Work Plan and Field Sampling Plan Site Investigations Fort Devens, Massachusetts

February 1992
Contract No. DAAA15-90-D-0012
Delivery Order No. 001
ELIN A004

Site Investigations Field Sampling Plan

Comments received from:

Figure 3-5 ILLUSTRATION OF STUDY AREA 32 (DRMO YARD)

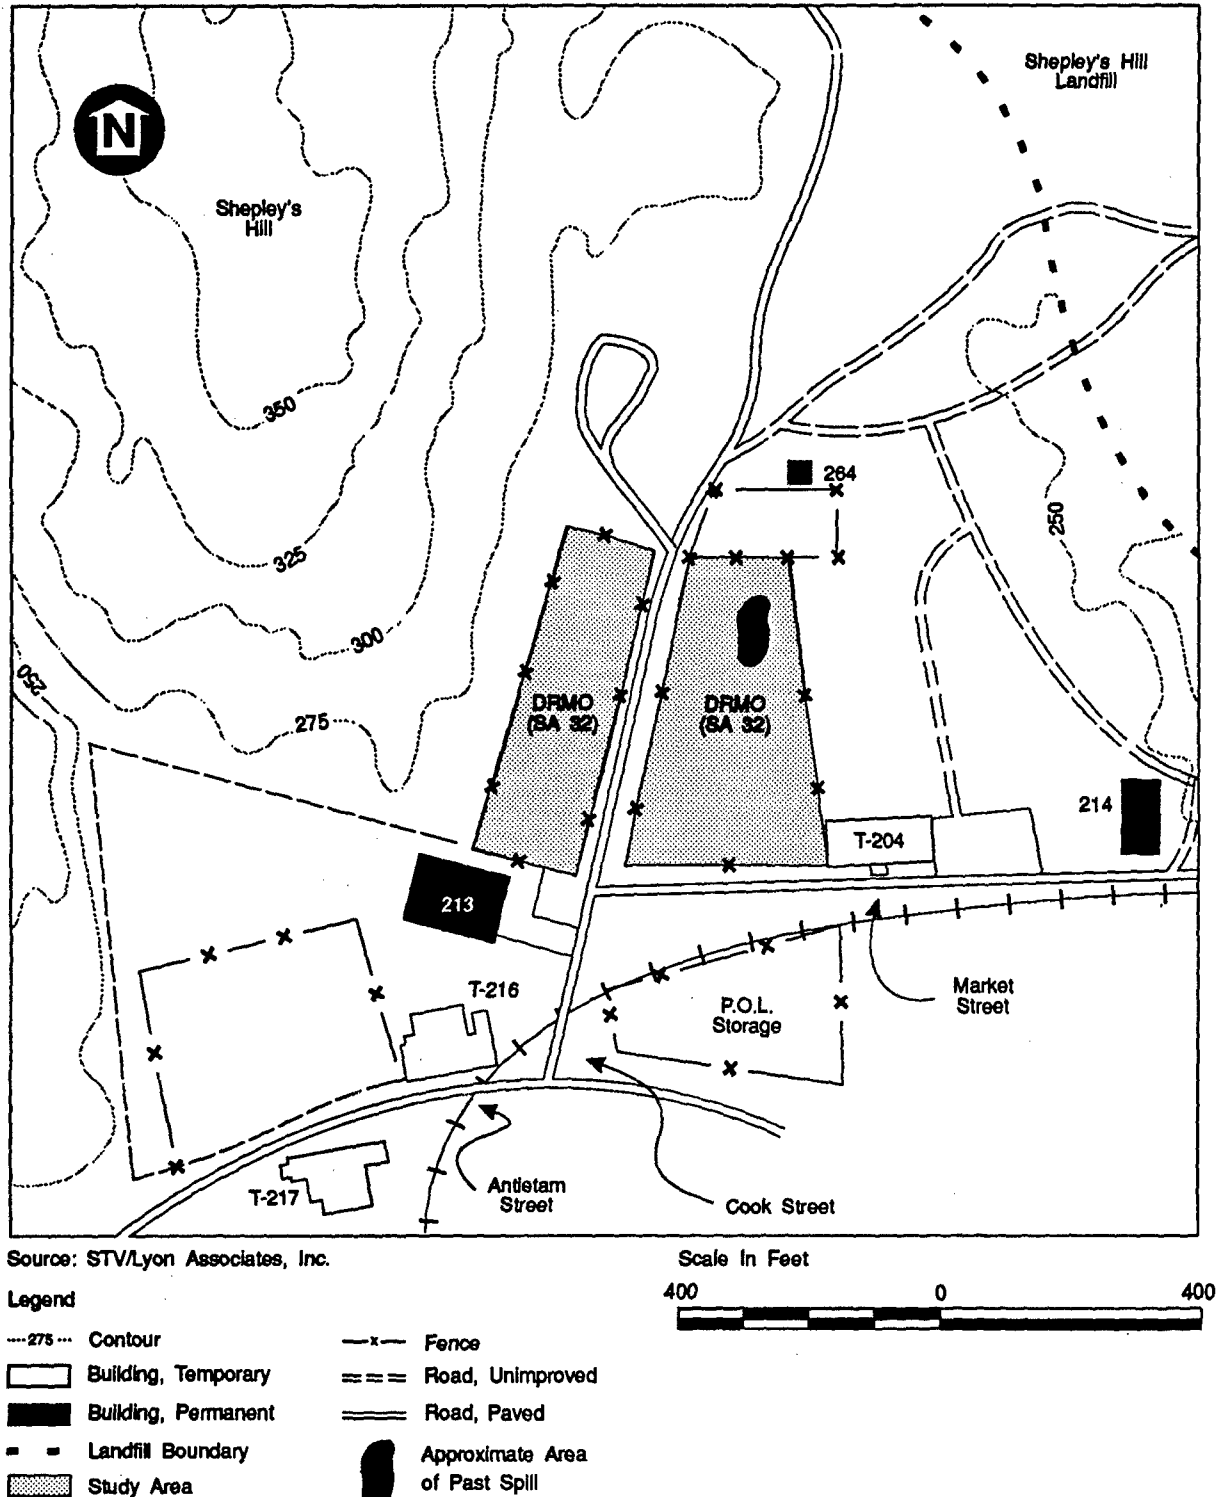
Comment-03: Section 3.5, last paragraph. Unless the soil analysis indicates that the soil has not been contaminated, this area should be included in the site investigation of SA 32. Please indicate if this area has been included in the sampling protocol. It would be helpful if the area in question was identified on the map 3-5 of the work plan and/or 2-4 of the field sampling plan.

Response: A number of investigations have been undertaken by other agencies at the DRMO besides the SI work currently underway. There have been recent spills of materials and cleanup actions. Fort Devens Environmental Management office conducted wipe tests for PCBs in late October 1991. AEHA is conducting a detailed sampling program of the spill areas. In addition, removal actions are occurring as evidenced by open excavations.

In response to this comment Figure 3-5 has also been changed to include a reference to the past spill site.
